# Value Engineering Study Report

*Project CSSTP-0006-00(869)*

*Big Shanty Road Connector*

RE: Submittal of the final Value Engineering Report  
Project No.: CSSTP-0006-00(869)  
P.I. No.: 0006869  
Big Shanty Road Connector  
PBS&J Project Task Order No. 31

# Illustration

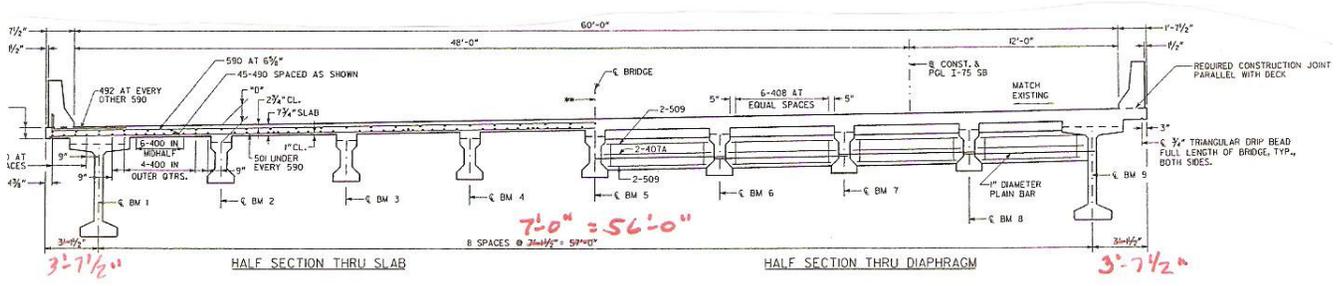
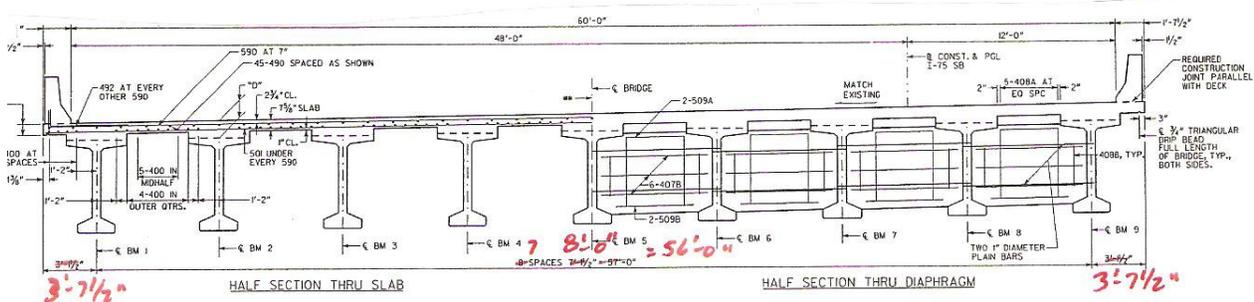
The original design uses 9 beams at 7'-1 1/2", in all spans on both bridges, with 3'-1 1/2" overhangs.

The alternative reduces the number of beams in Span 2 on both bridges to 8 by increasing to 8'-0" and increasing the overhangs to 3'-7 1/2".

The number of beams in Span 2 on both bridges can be reduced to 8 by increasing the spacing to 8'-0" and 3'-7 1/2" overhangs. Based on GDOT PSC beam design charts the Bulb Tee 63 will span the required distance at 8'-0" spacing. In Spans 1 & 3 the wider beam spacing may not work without increasing the beam size but the same number of beams can be utilized at a spacing of 7'-0". The overhangs of 3'-7 1/2" in these spans is slightly greater than the typical half of the beam spacing but with Bulb Tee 63 fascia beams this is acceptable.

# Illustration

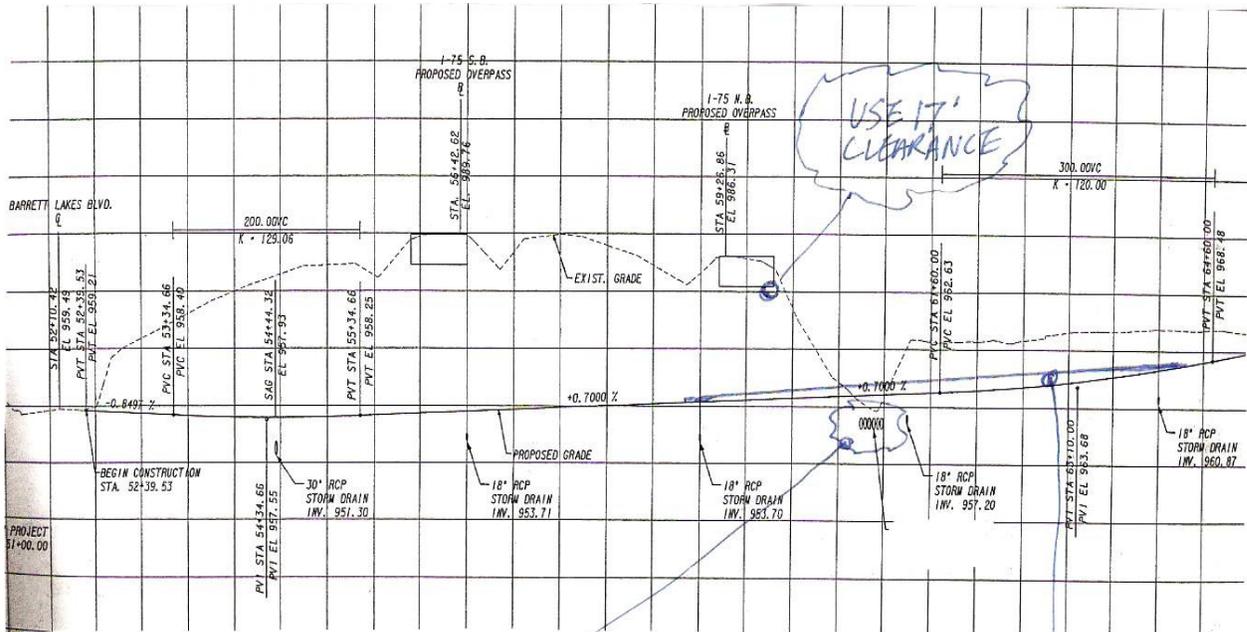
DESCRIPTION: **Modify drainage structures at STA. 60+88 +/-**

# Illustration

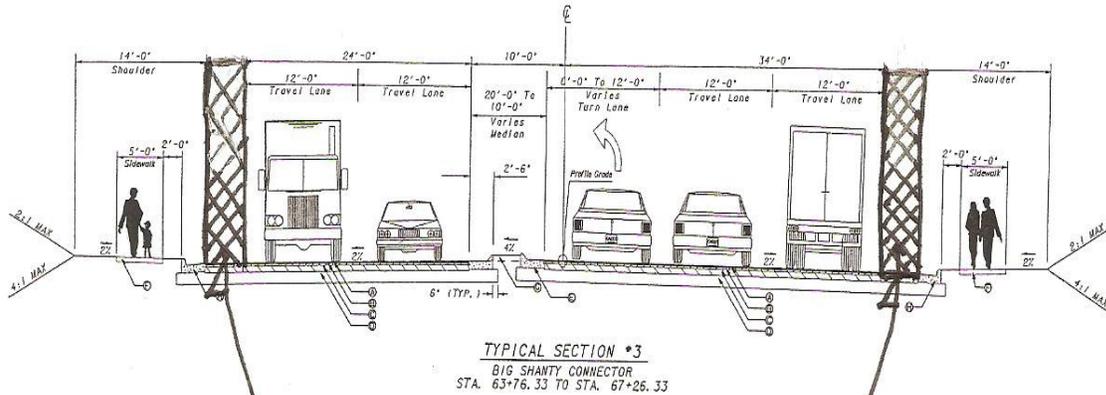
The alternative would delete the bike lanes from the project in its entirety.

The alternative proposes to remove the bike lanes from the project entirely. There are no reciprocal bike lanes at either end of the logical termini on the east and west limits of the project, thus no continuous route will be constructed for thru bike traffic. The benefits of deleting bike lanes would include cost savings for pavement build-up, and less R.O.W. would be required. The identified risks of deleting the bike lanes would include the possibility of future widening on connecting routes to include a bike lane, leaving the present project without that alternative.

# Illustration

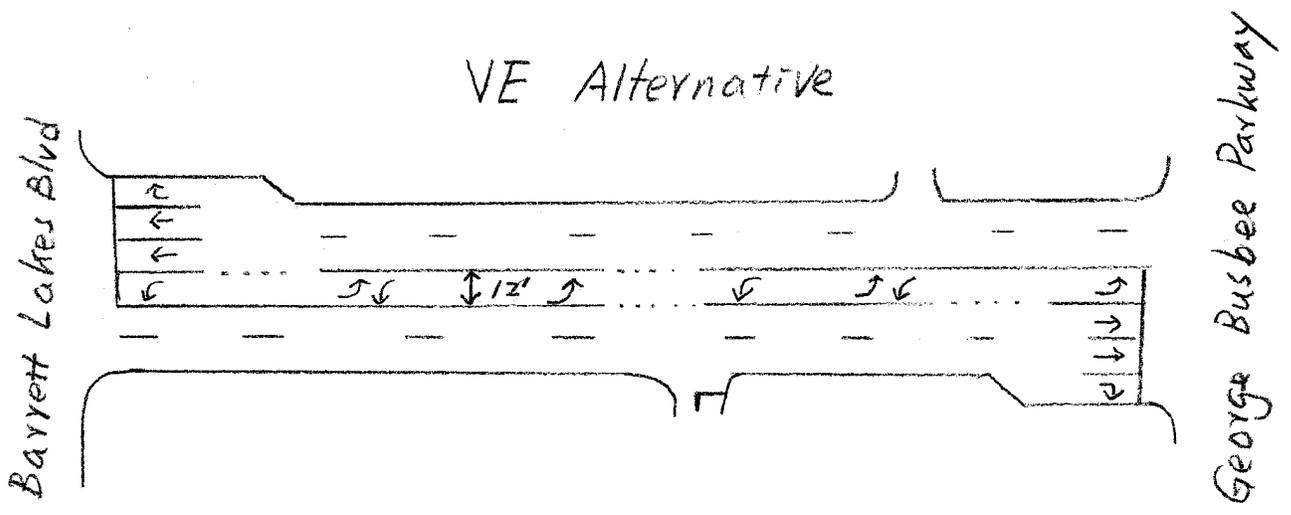
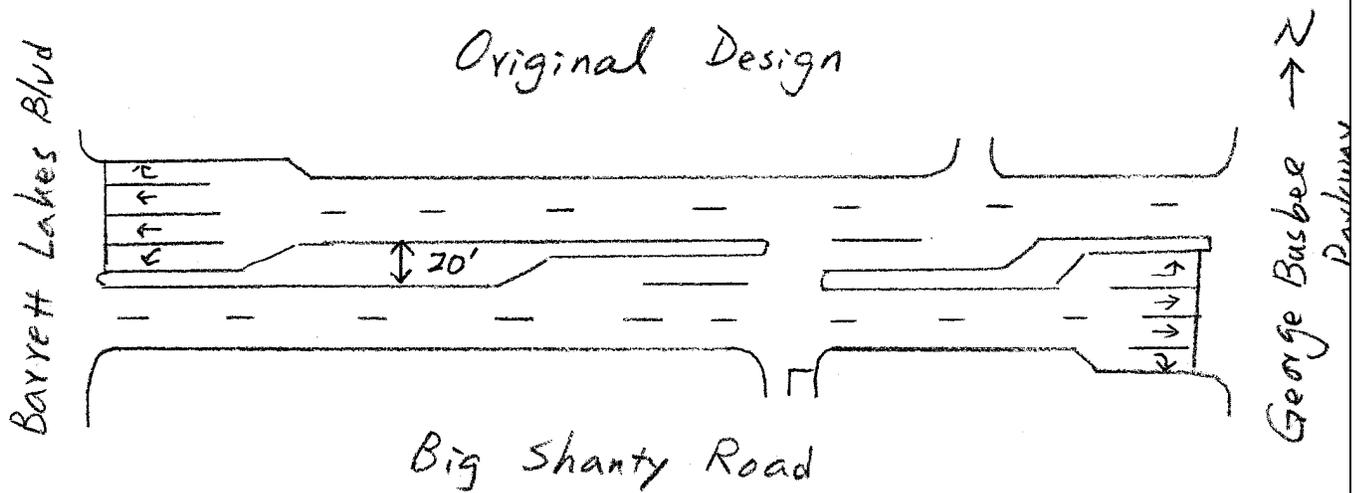
A two-way left turn lane would still provide a separation of opposing traffic. It would also enhance the access to adjoining properties.

Figure 1. Original Design with Future HOT Intersection.

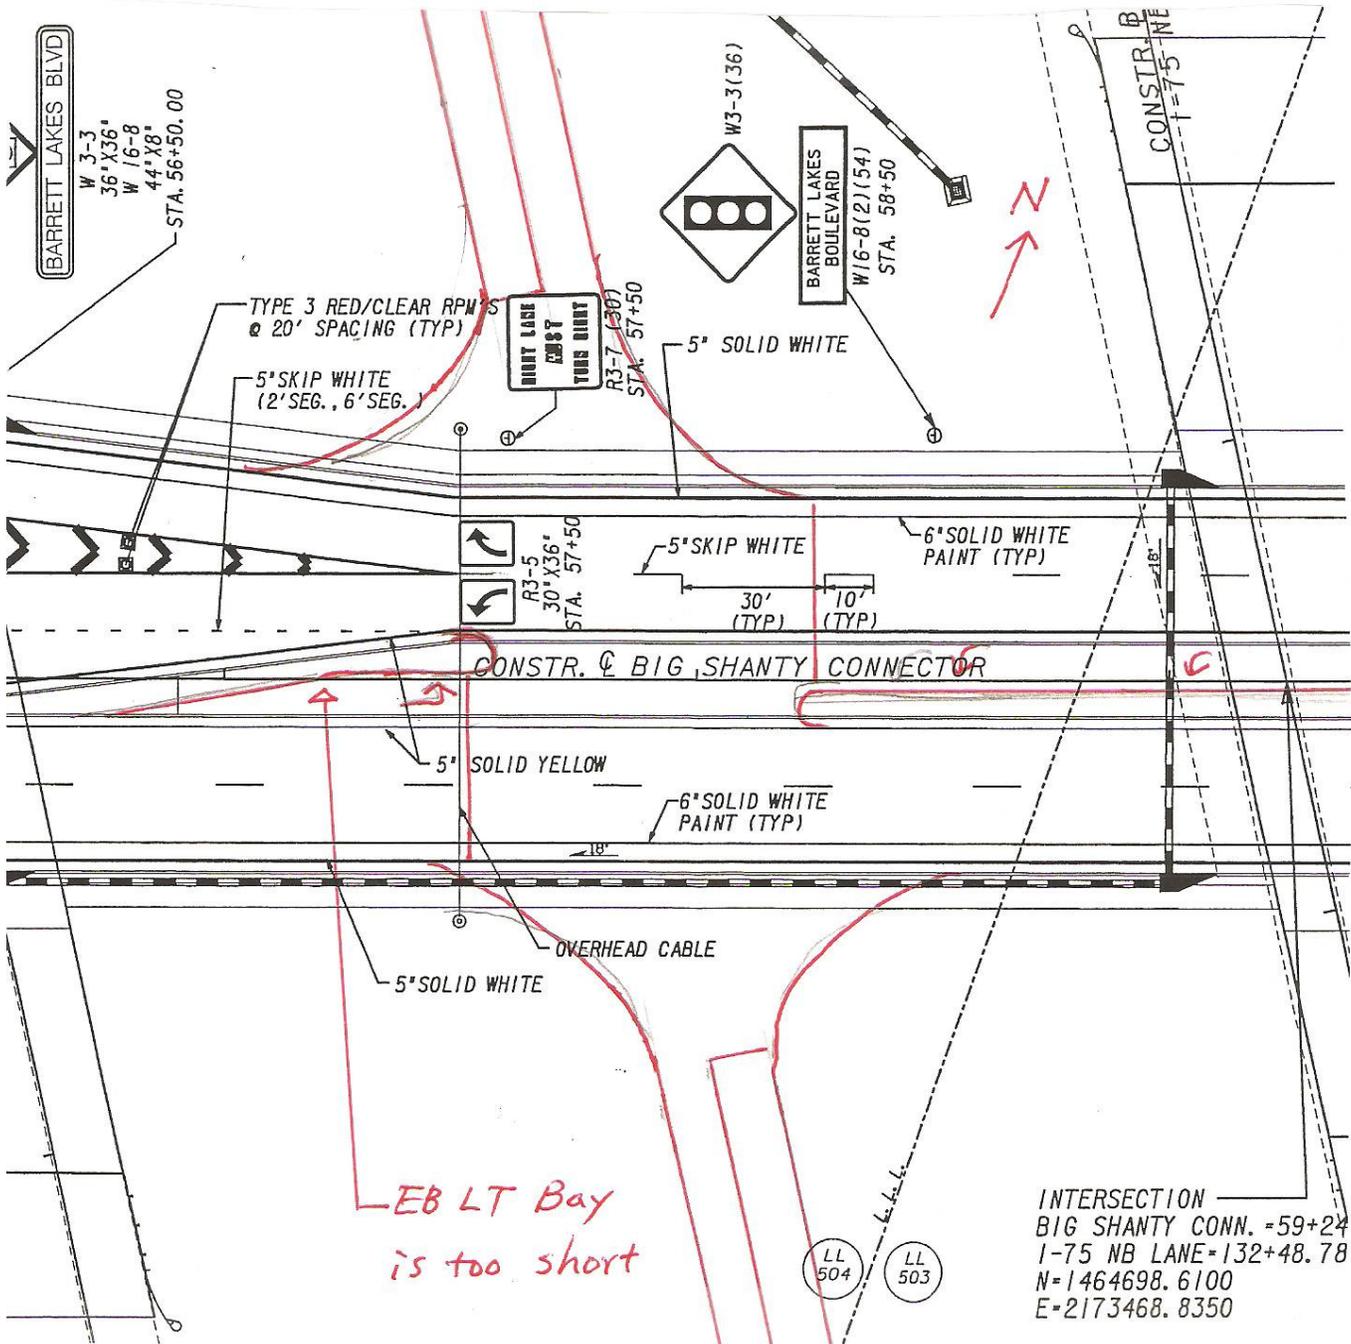
As shown in Figure 1, the original design uses the median on Big Shanty Road to provide a westbound left turn bay at the Barrett Lakes Boulevard intersection. The problem is that the beginning of the westbound left turn bay almost reaches the future HOT ramp terminal access intersection for the I-75 PPI project. There is no room in the median to provide an eastbound left turn bay at the HOT ramp terminal access intersection.

Figure 2. VE Alternative with Future HOT Intersection

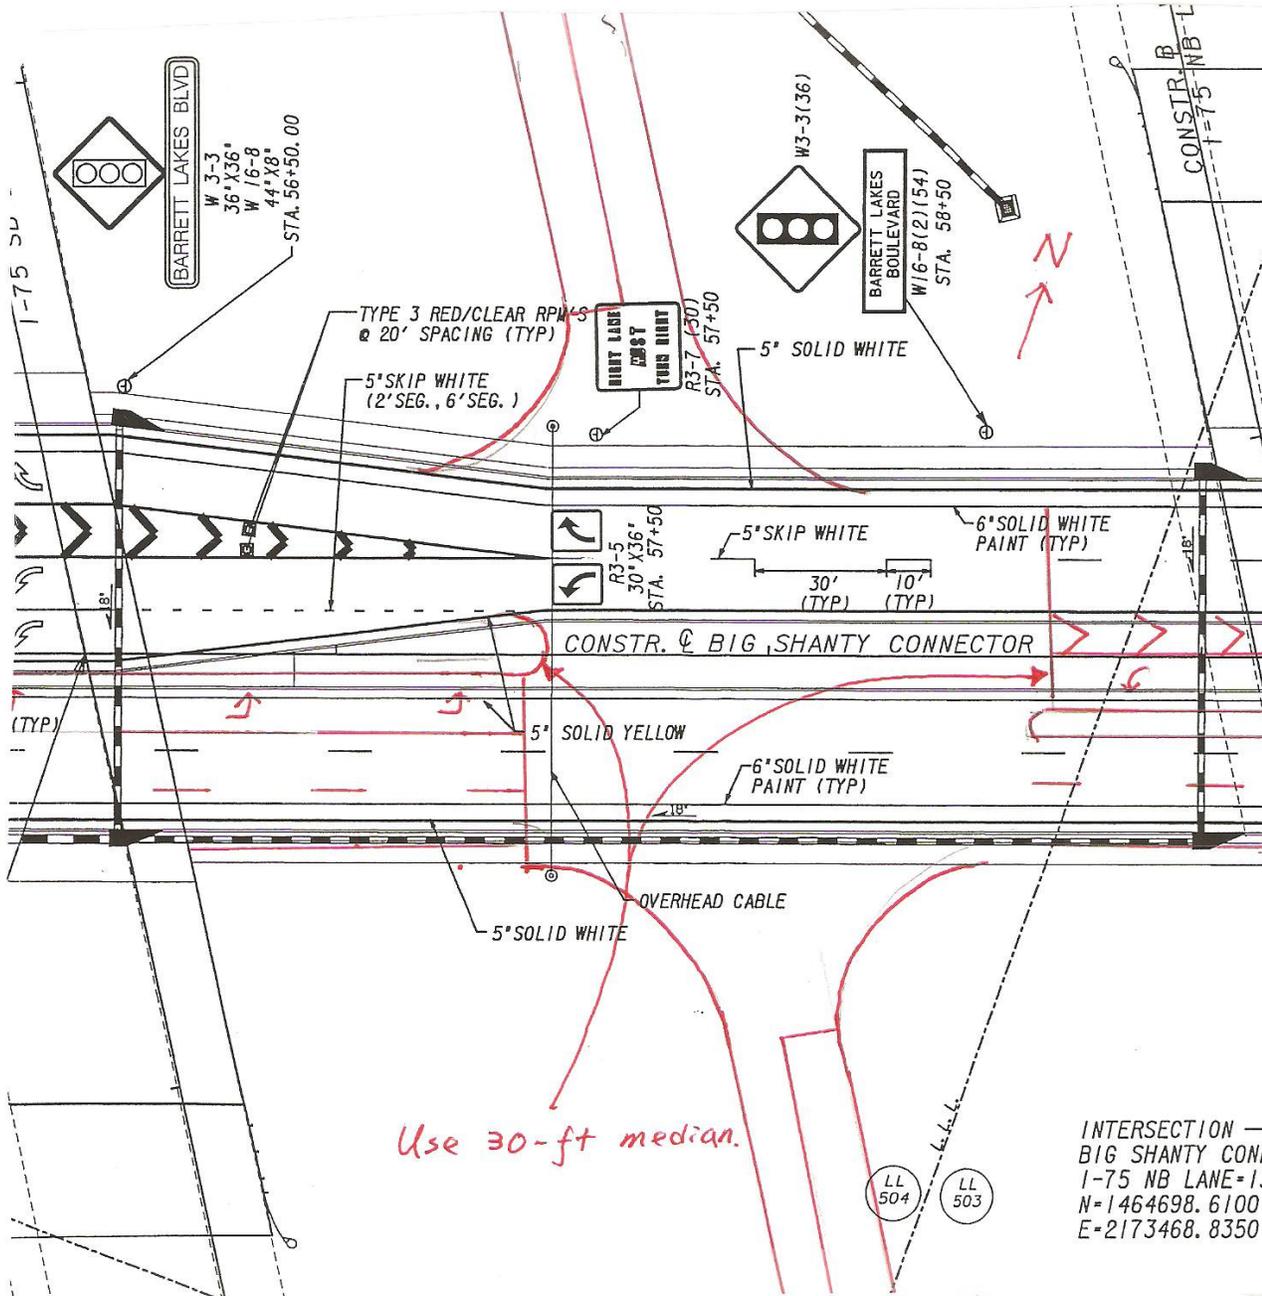
As illustrated in Figure 2, the alternative is to use a wider median on the section of Big Shanty Road under the I-75 bridges so that a pair of parallel left turn bays (westbound left turn for Barrett Lakes Blvd and eastbound left turn for HOT ramp terminal access) could be provided in the median; or reduce the current plan by removing bike lanes, removing one sidewalk, reducing R/W, using MSE wall abutments which would reduce the obligated space and allow for the additional lane without significant impact to the project.
